**Subject: LLO Repair Comment Response
Pickens County
Permit #112-009-00462**

Big Canoe Property Owners Association (POA) and its consultant Geosyntec Consultants, Inc. (Geosyntec) received the Safe Dams Program (SDP) comments on the plan set for restoration of the low-level outlet (LLO) operability for Lake Petit Dam (Dam) in your letter dated 25 June 2024. For continuity and clarity, we have listed each of your comments from this letter below, along with our responses.

LLO REPAIR

LAKE PETIT DAM

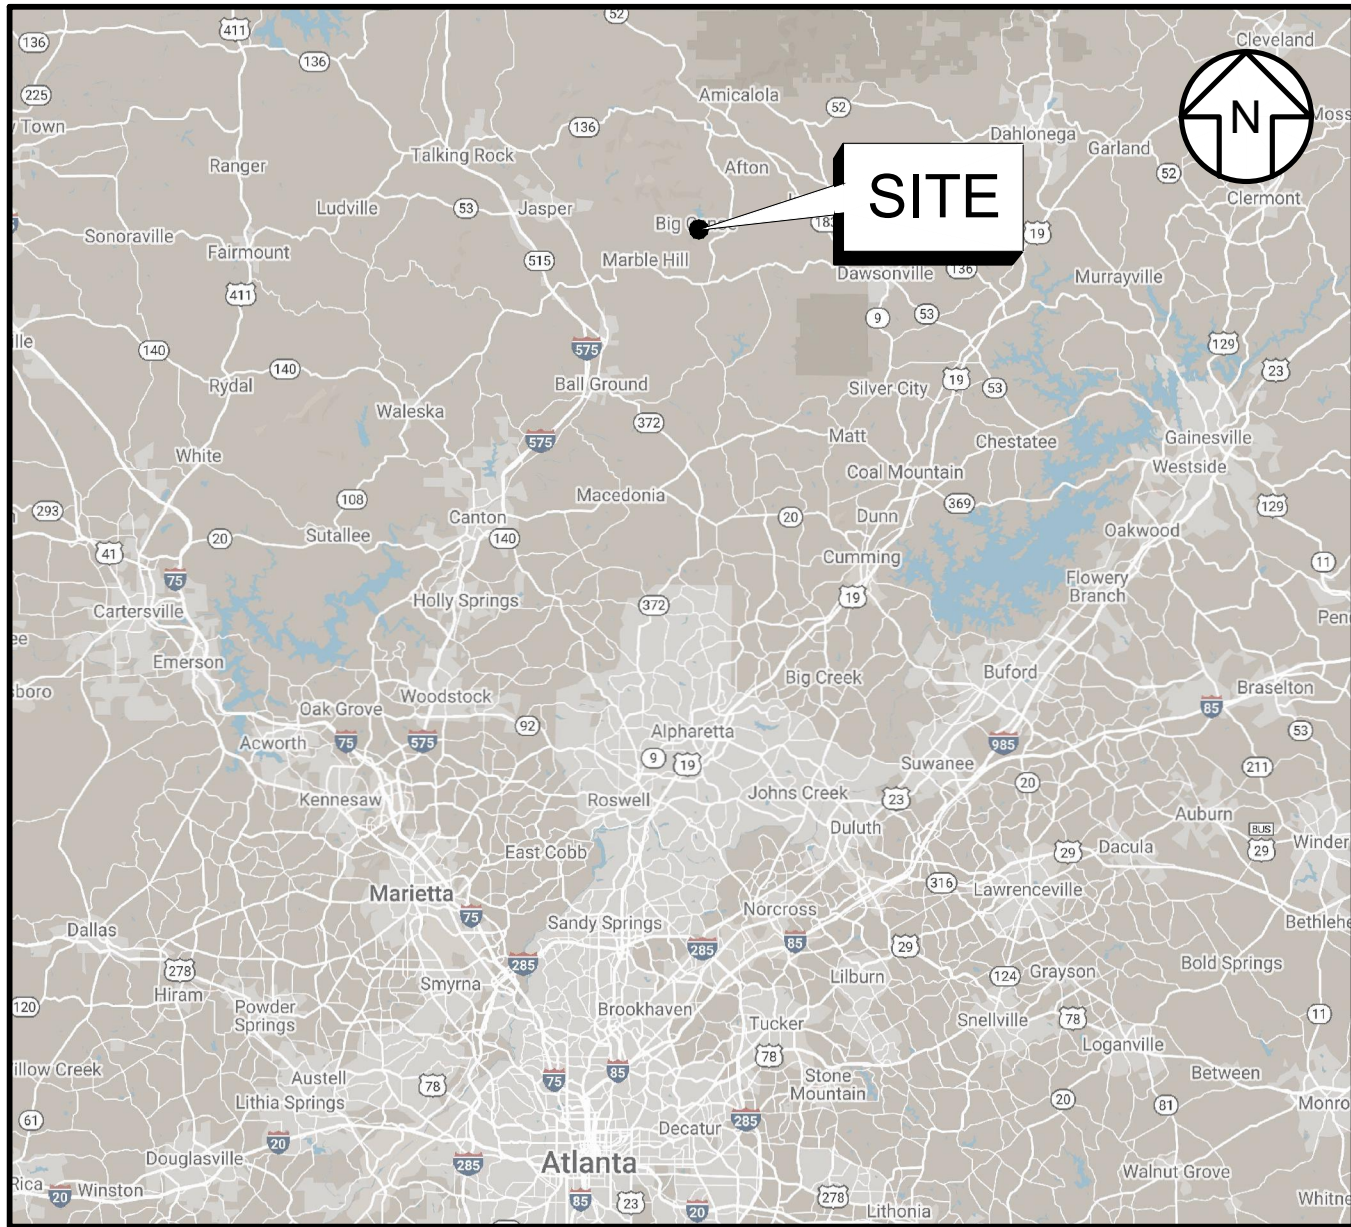
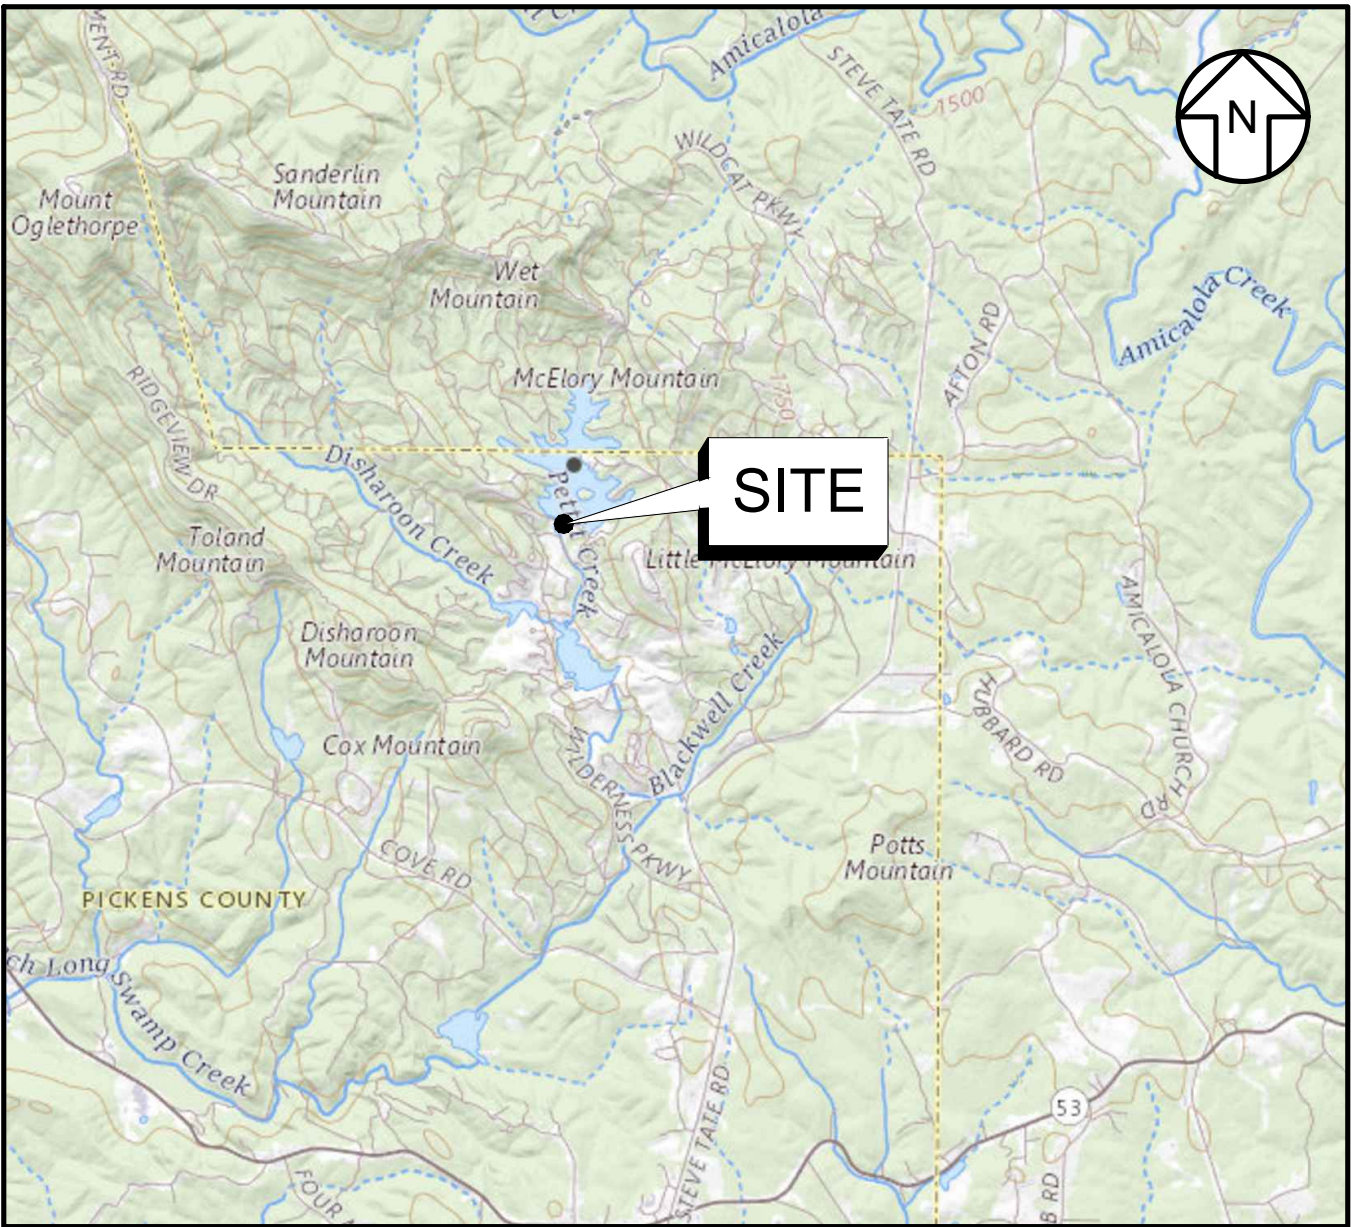
2. A 24-hour contact must be added to the first sheet of the plans.

Geosyntec – Contact information has been added to cover sheet.

24 HOUR - LLO REPAIR CONTACT:
LYDELL MACK
BIG CANOE PROPERTY OWNERS ASSOCIATION
PHONE: 678.578.9763

5 PROFILE
4 PROPOSED FRAME SYSTEM
SCALE: N.T.S.

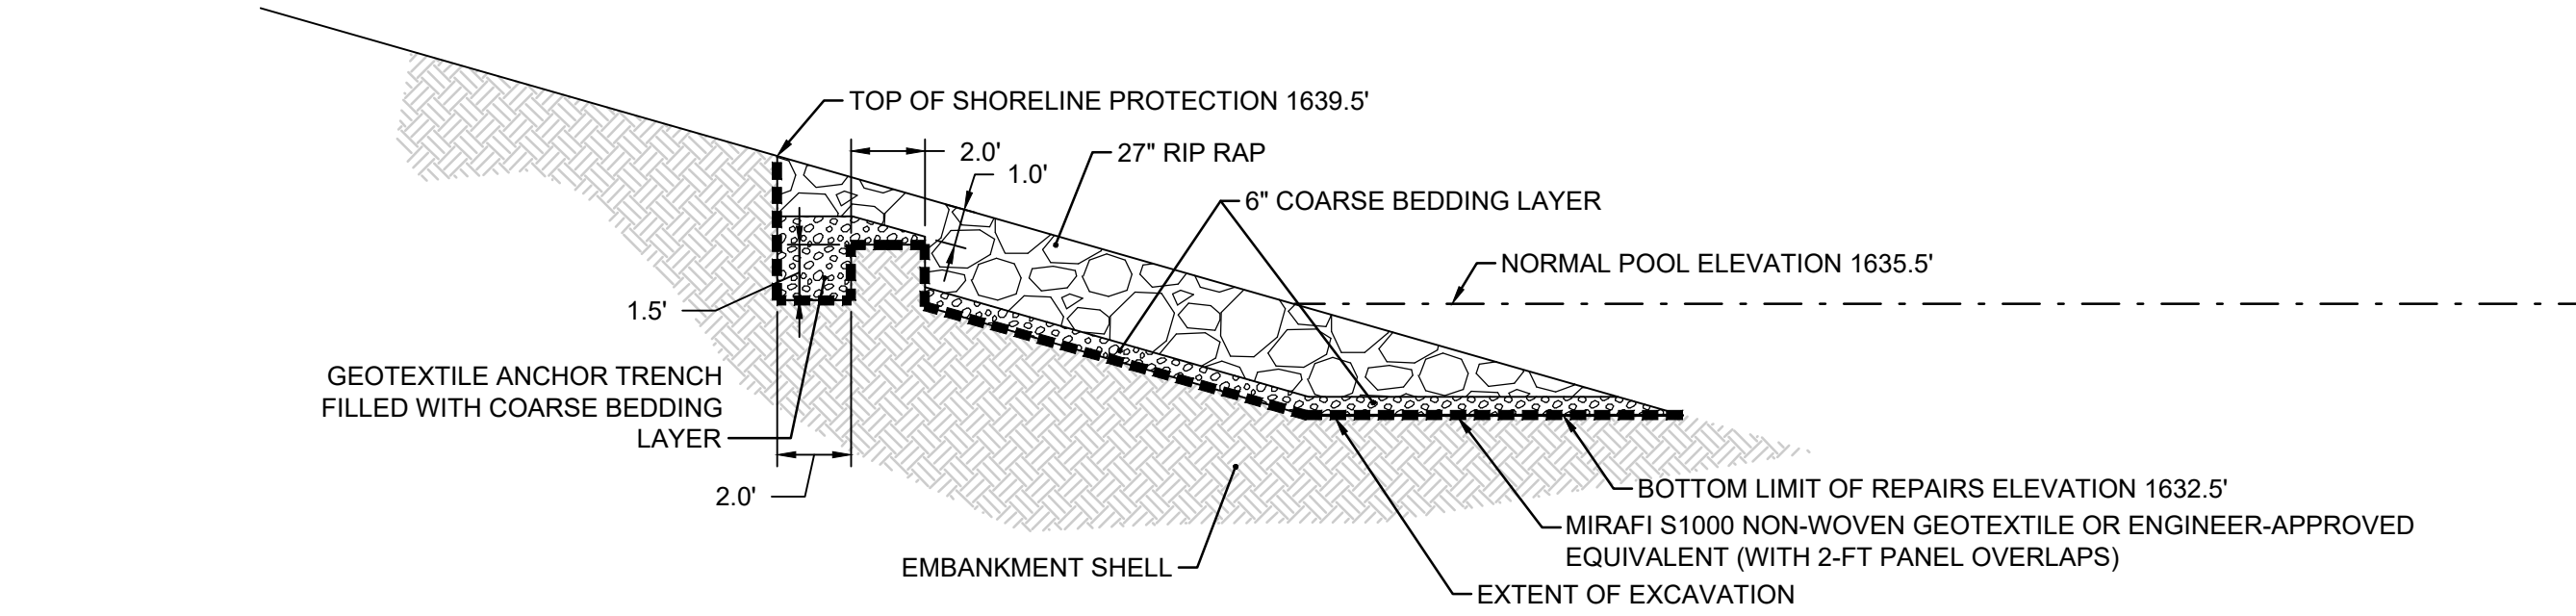
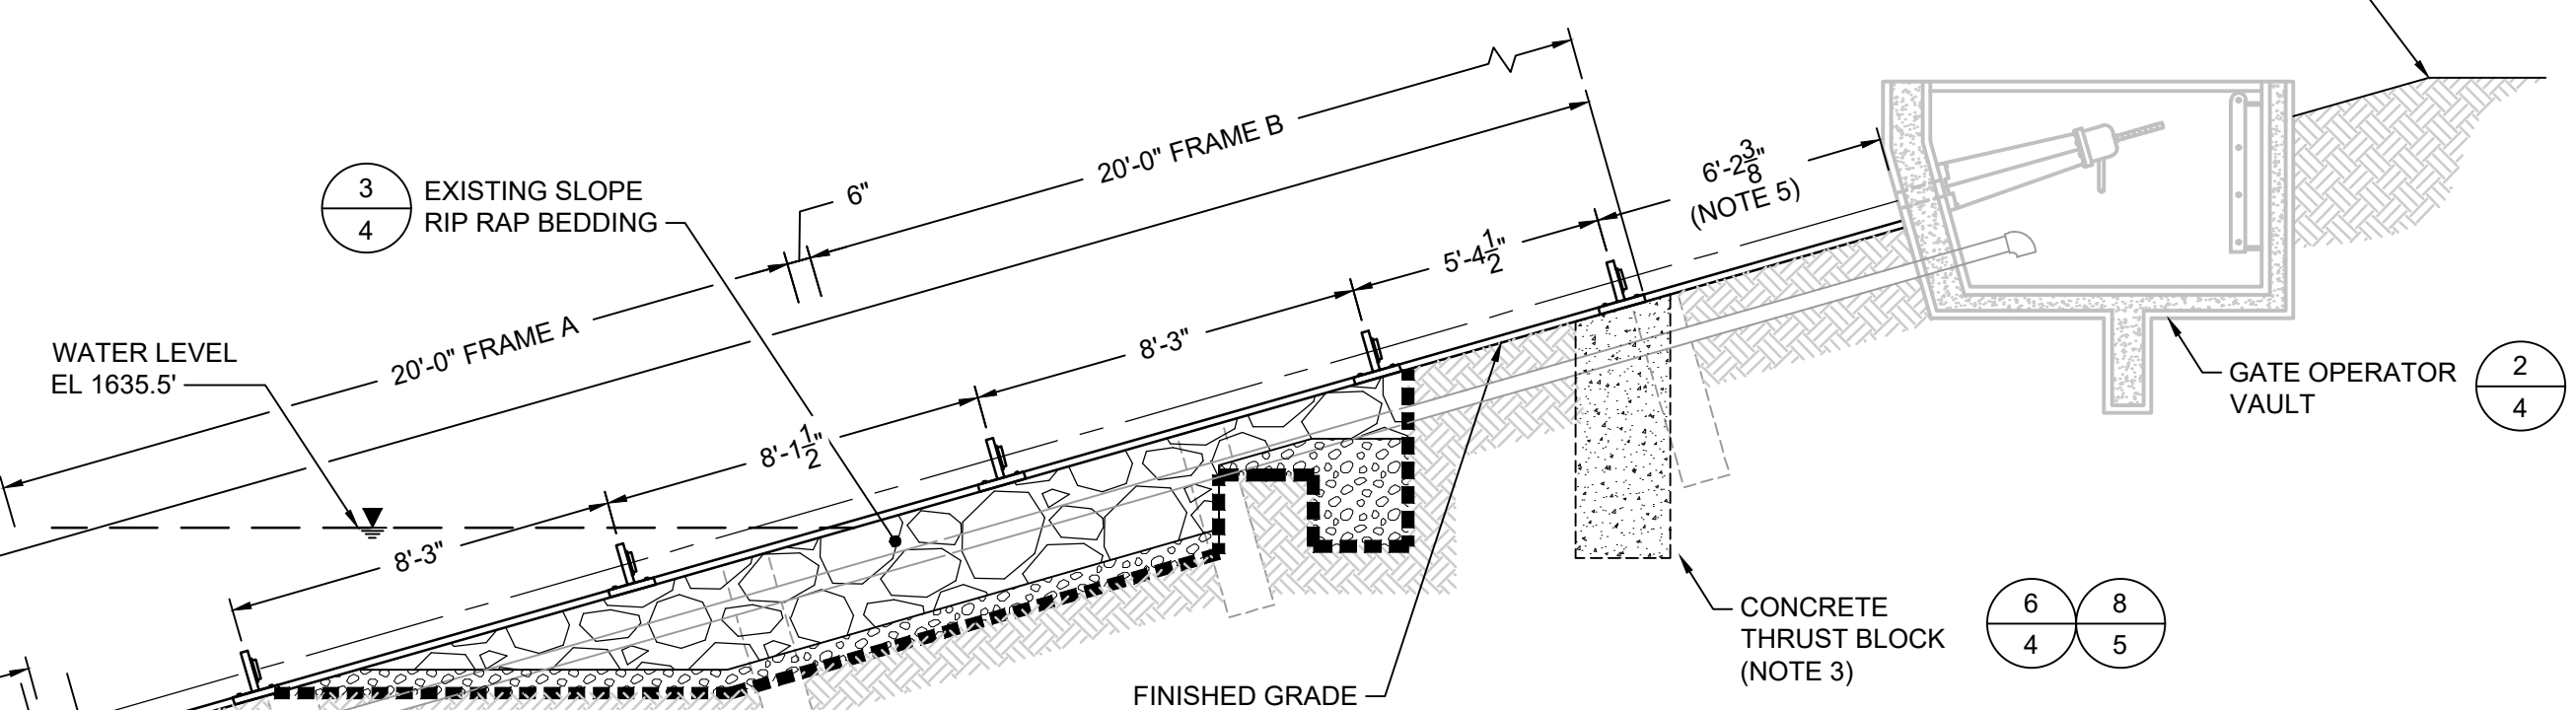
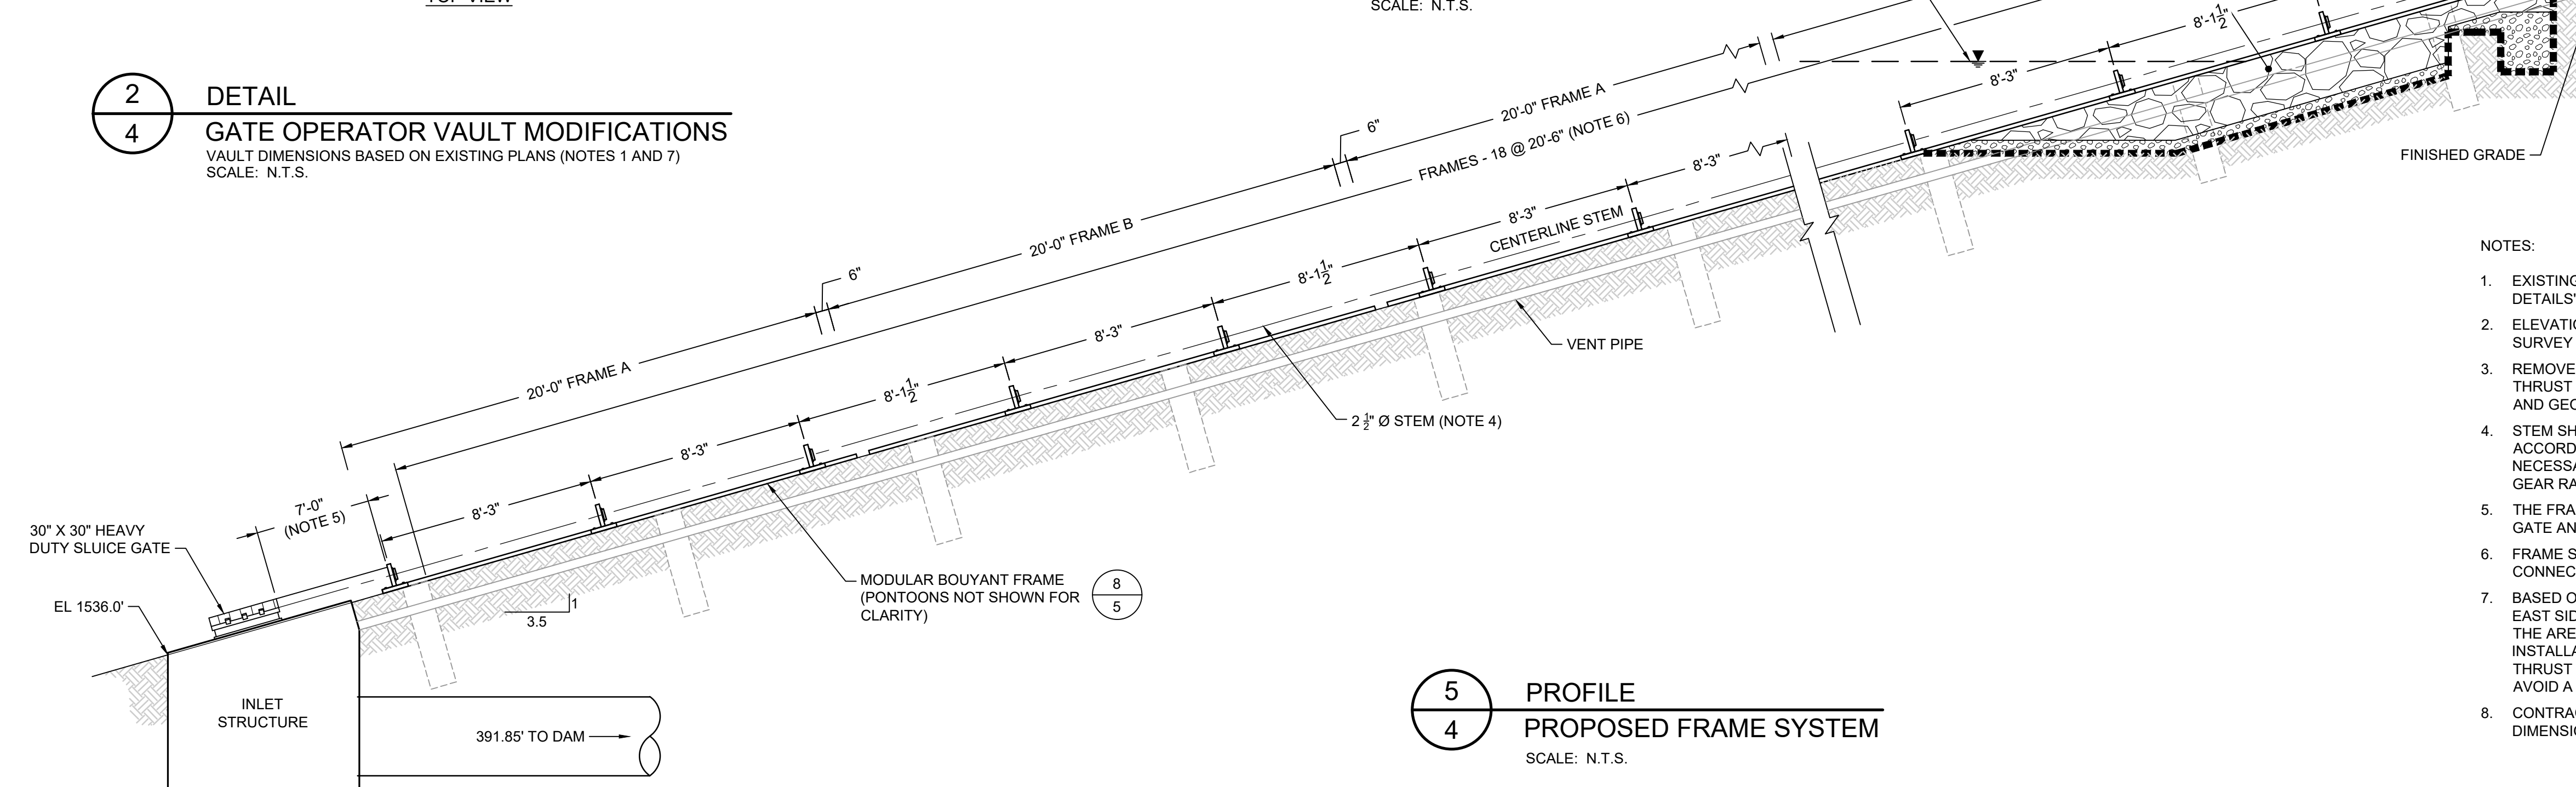
4. Are there environmental concerns or regulations related to possible re-routing or relocating of the asbestos cement vent pipe in Note 7, Sheet 4?

Geosyntec – The plan notes have been revised to remove the option of relocating the vent pipe.

7. BASED ON PRIOR WORK AT THE SITE, THE VENT PIPE LOCATION IS BELIEVED TO BE ON THE EAST SIDE OF THE VAULT CENTERLINE. CONTRACTOR SHALL EXPOSE THE VENT PIPE IN THE AREA OF THE THRUST BLOCKS PRIOR TO EXCAVATION FOR THRUST BLOCK INSTALLATION. DEPENDING ON THE FIELD LOCATION OF THE VENT PIPE, THE EASTERN THRUST BLOCK MAY BE SLIGHTLY RELOCATED, AT THE APPROVAL OF THE ENGINEER, TO AVOID A CONFLICT.

DETAIL
THRUST BLOCK
SCALE: N.T.S.

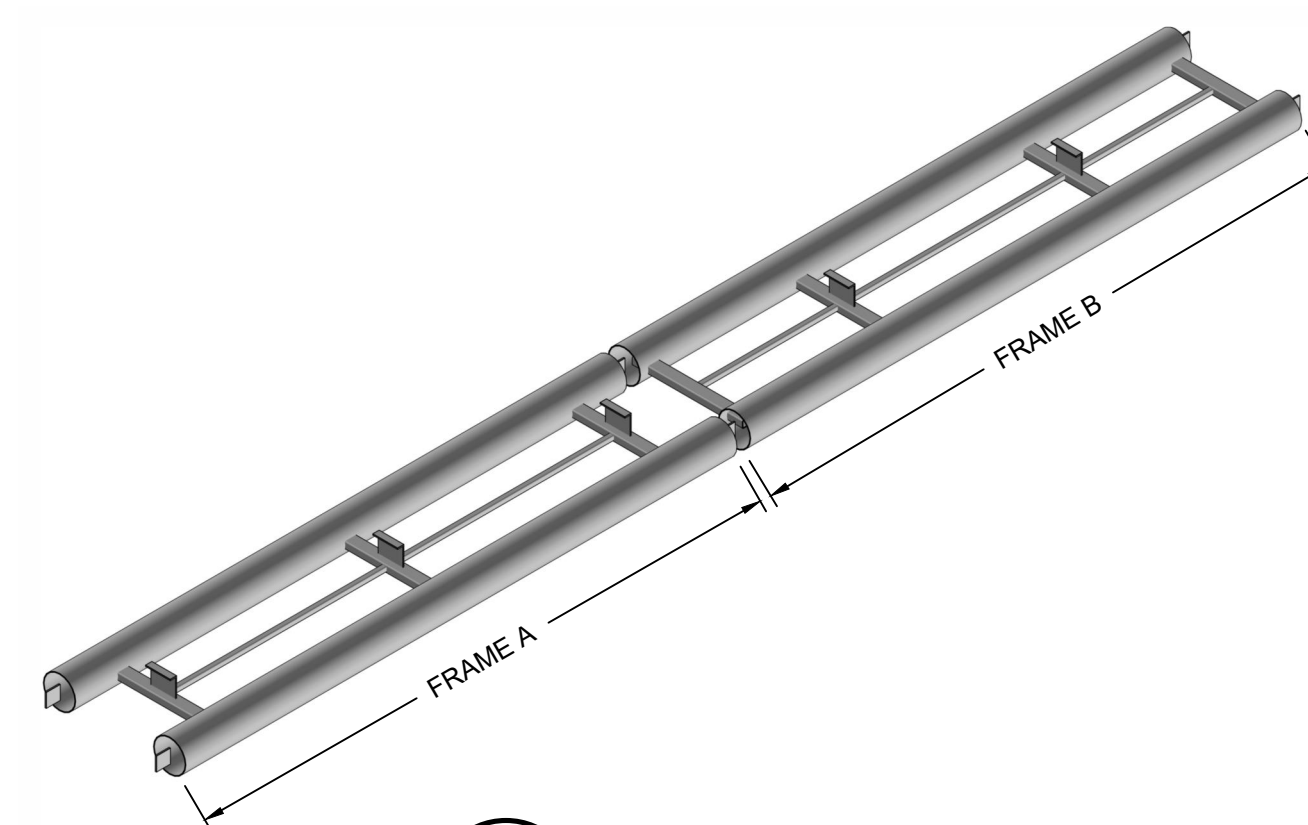
7. Will there be reinforcement in the anchor blocks? If so, verify it will not conflict with the 1/2-inch diameter threaded rods embedded a minimum of 6 inches in the anchor block. If not, please explain why it is not needed.

Geosyntec – See Detail 6 on Sheet 4 for reinforcement detailing. There is no structural impact should reinforcement be intercepted by the frame anchors as this reinforcement is not the primary structural reinforcement and is provided to control temperature and shrinkage cracks.

DETAIL
FRAME SECTION
SCALE: N.T.S.

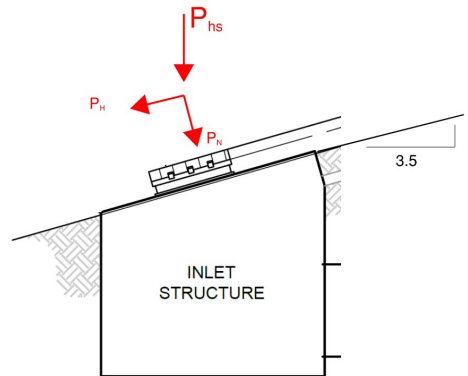
6. Please clarify the apparent discrepancy of the HSS 14X0.25 showing a thickness of 3/16-inch in Detail 12, Sheet 5. Please better define the connections between the HSS 2X2X3/16 and HSS 5X3X3/16 members of the frames.

Geosyntec – There is no discrepancy in the plan set. The frame is comprised of three different Hollow Steel Shapes (HSS). The longitudinal side members are circular tubes with a 14-inch outer diameter and 1/4-inch wall thickness. The cross-frame members are rectangular tube sections measuring 5-inches by 3-inches with a 3/16-inch wall thickness. The center longitudinal member between the cross-frame members is a 2-inch by 2-inch square HSS with a 3/16-inch thickness. The connections between the HSS framing members is a 3/16-inch fillet weld all the way around the perimeter of the square/rectangular HSS members.
